VIRGINIA ELECTRIC AND POWER COMPANY

We submitted a letter to you on March 16, 1978 stating that certain information would be provided regarding our November 22, 1977 submittal for the permanent solution of the low head safety injection and recirculation spray pumps net positive suction head problems. We are still working with our A-E to provide responses to all of your requests. Responses to requests 1.0, 3.0, 9.0 and 12.0 are attached. We will continue to forward responses to the remainder of your requests as the information becomes available.

RESPONSES FOR NRC
REQUEST FOR ADDITIONAL INFORMATION
SURRY POWER STATION, UNITS 1 AND 2
DOCKET NOS. 50-280/281

FIGURE 3.1-1

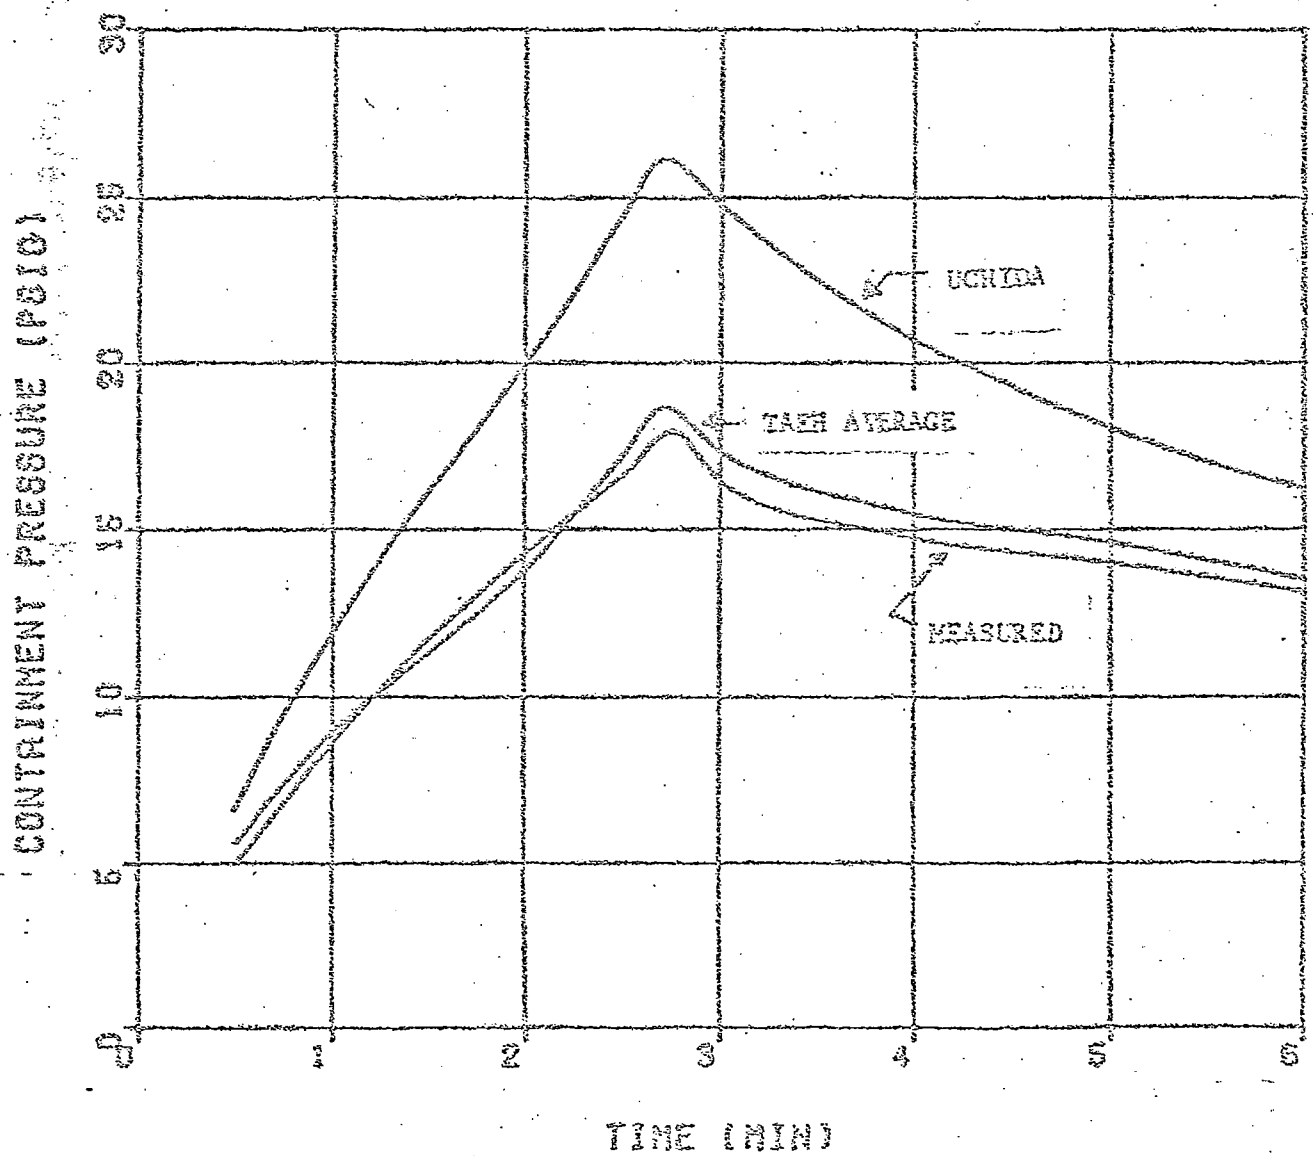
A discussion of the conservatism in the heat transfer correlations used to calculate the heat transfer from the containment atmosphere to the passive heat sinks and vice versa:

The use of the Tagami condensing coefficient is very conservative, as exhibited in Figure 3.1-1. The measured pressure transient was obtained from Test 3 of the Simulated Design Basis Accident tests of the Carolinas Virginia Tube Reactor Containment (Reference 3-2). The CONTEMPT best estimate calculation using the Uchida condensing coefficient generates a peak pressure 45 percent greater than the measured peak. The use of the Tagami condensing coefficient would yield a similar result.

Better agreement with the data is achieved using the TAEH average coefficient to calculate the condensing heat transfer. Figure 3B of Reference 3-2 indicates that the TAEH average coefficient is four times the Uchida value at the time of peak pressure.

FIGURE 9.0-1
RECIRCULATION SPRAY PUMP
NPSH MODIFICATION
SHEET 1 & 2

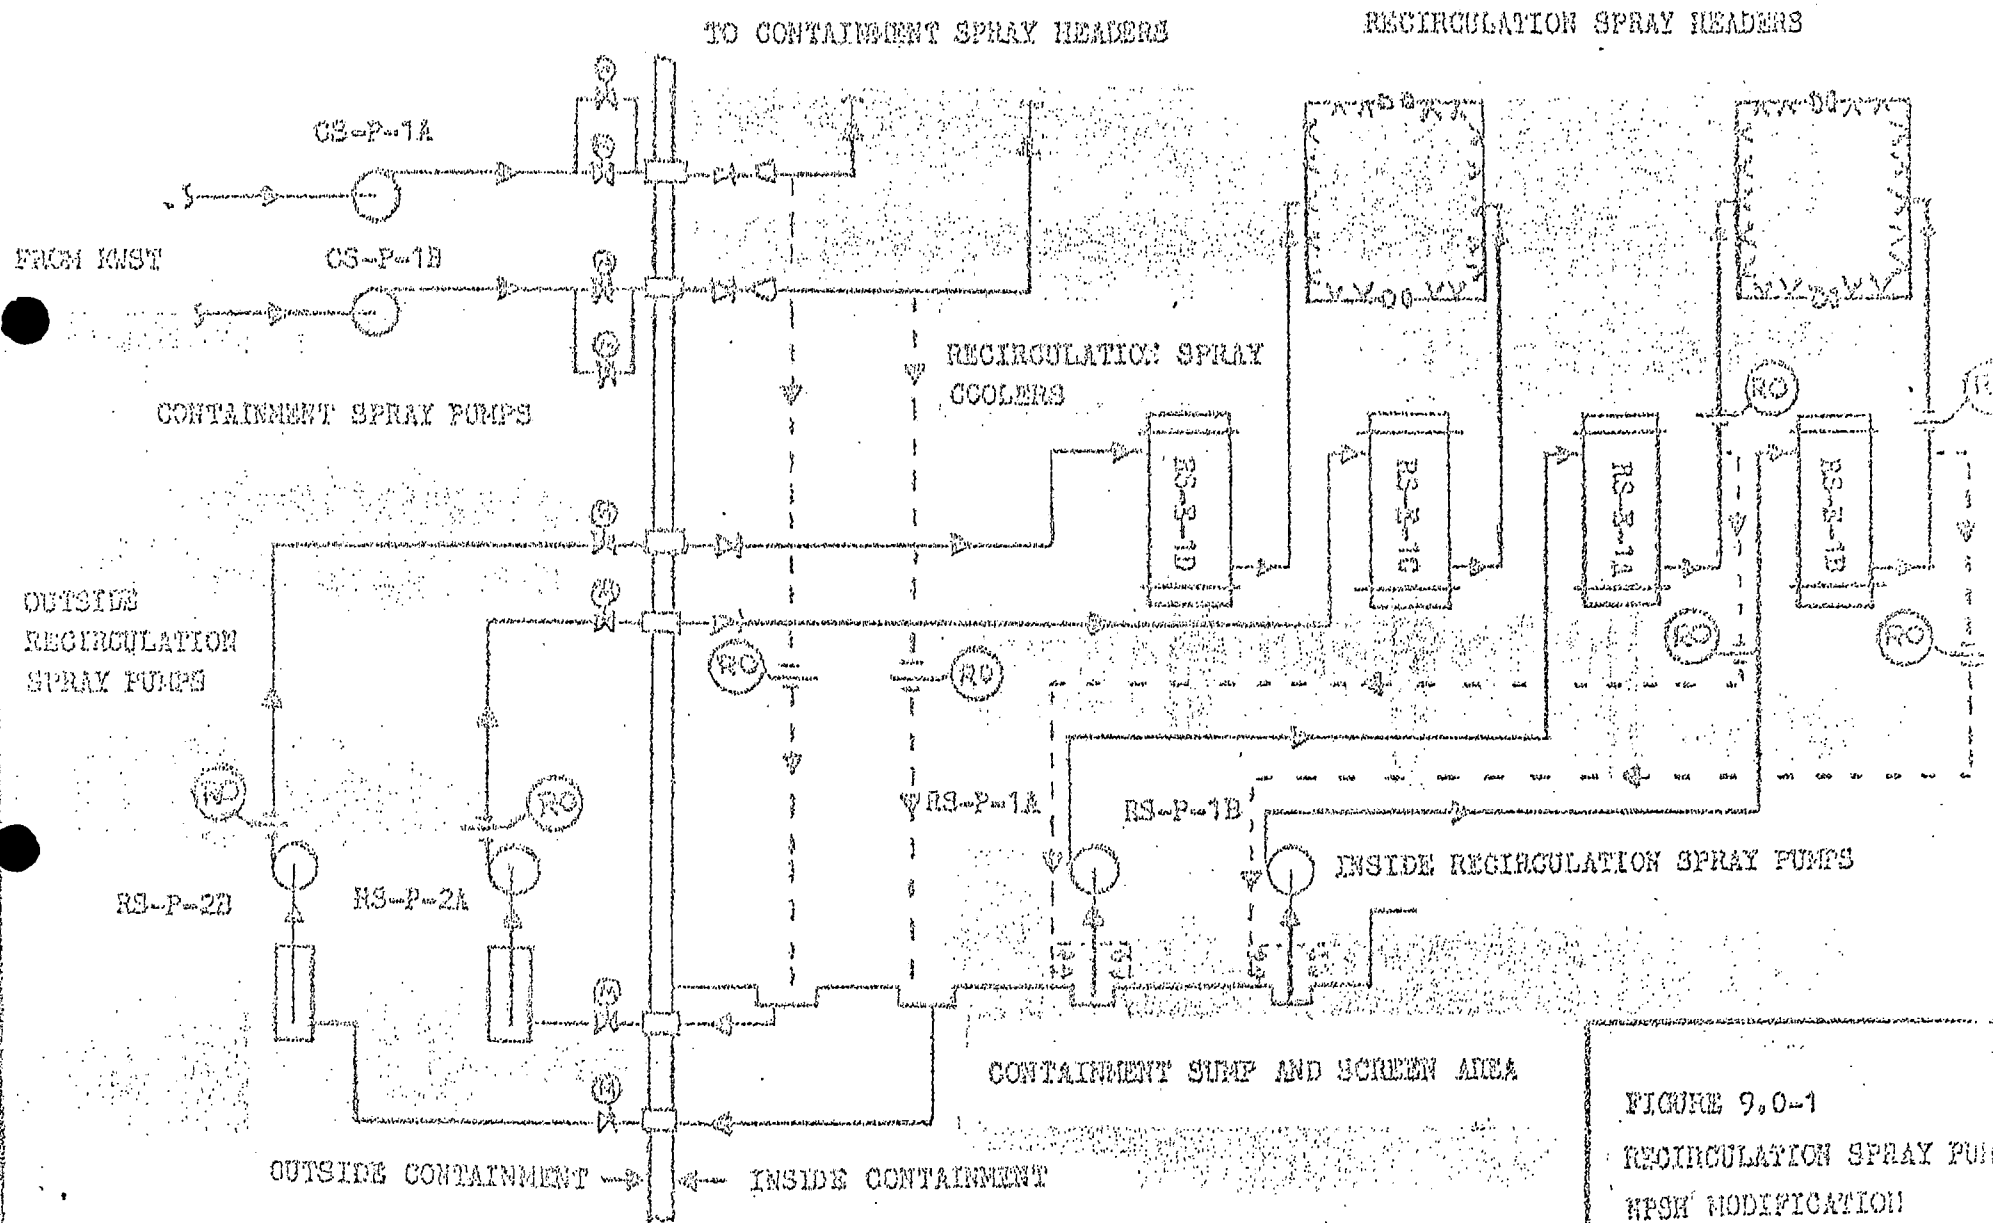
Provide a detailed schematic drawing to show the modifications of the containment recirculation spray system.

See Figure 9.0-1 " Recirculation Spray Pump NPSH Modification"

FIGURE 12.0-1
INSTALLED CAVITATING VENTURI
PERFORMANCE TEST
SUNNY 1 & 2

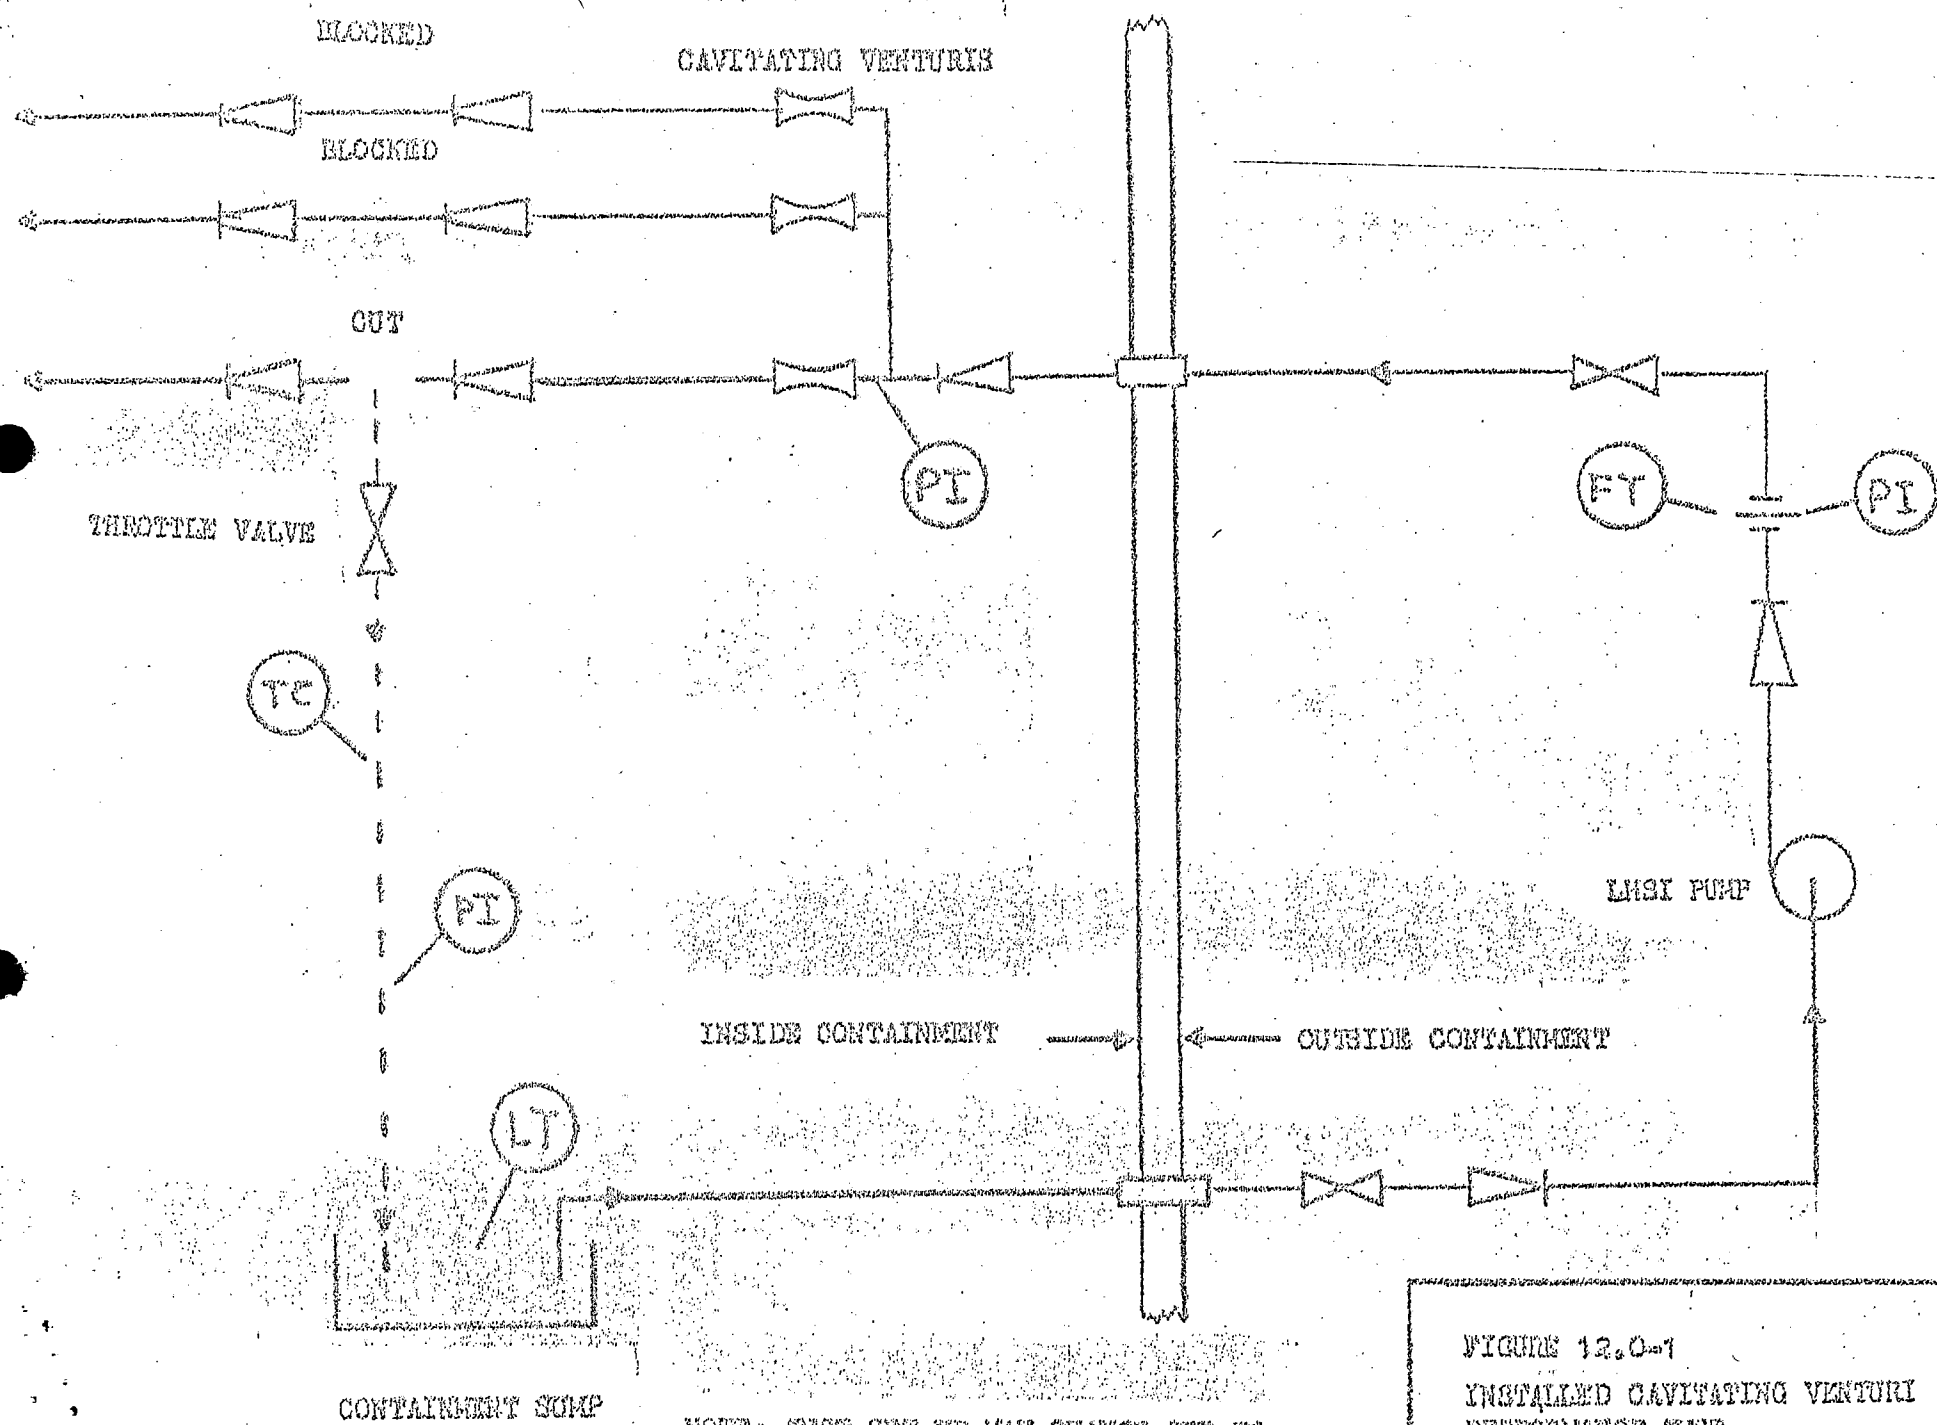
Submit all cavitating venturi sizing calculations. Describe the flow tests to be performed to verify both the system pressure drop and flow rate with the cavitating venturi installed.

After installation in the plant a performance test will be conducted using one LHSI pump in the recirculation mode. The maximum flow passed by the cavitating venturis depends on the inlet pressure. Since the venturis are located close to the three branch flow split, each will have the same inlet pressure. Hence, only one of the three branches to the reactor coolant system will be tested. The flow path and instrumentation is shown in Fig. 12.0-1, "Installed Cavitating venturi Performance Test." As shown in the drawing, the safety injection branch line will be cut and temporary piping will be routed back to the containment sump. A throttle valve will be utilized in the temporary piping to vary the downstream pressure.

The parameters that will be measured are the sump water level, the pump flow, the pump discharge pressure, the venturi inlet pressure, the pressure downstream of the temporary throttle valve, and the temperature of the water.

With one LHSI pump running, the throttle valve will be opened in steps until a constant flow is reached. The valve will then be opened further to show that the maximum flow passed by the venturi for a constant inlet pressure does not increase with decreasing downstream pressure.

The installed cavitating venturi performance will be acceptable if the measured maximum flow rate and corresponding venturi inlet pressure are within the respective ranges predicted for the test conditions. The predicted ranges depend upon conservatively high and low values for the system friction pressure loss and for the total dynamic head of the pump.
